655/7. Subject: - An estimate for repairing the principal structures at the seven pagoda

12th April 1881, No. 967 W.

SEVEN PAGODAS.

No. 15, or Krishna Mundapam.—In this there are very bad leaks down the back over the sculptures, the roof is stone slabs with earth over them, and where it abuts against the rock behind there is no proper drain.

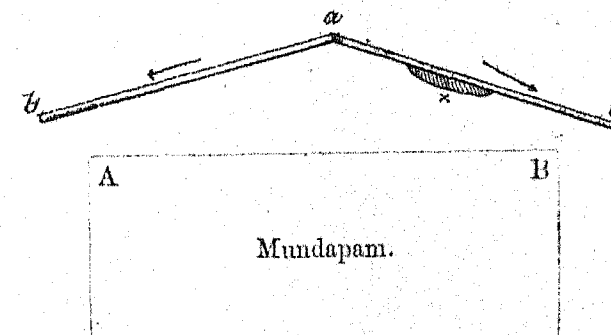
Small drains *a b, a c* should be made sloping downwards the face *A B* of the Mundapam being cut out of the rock and the roof being about the level of the top of the rock which slopes upwards to *a*.

There should be a small wall built on the lower side, a notch being cut as a footing. The work will be—

Stone slab on edge fixed in a groove to be cut in the rock.
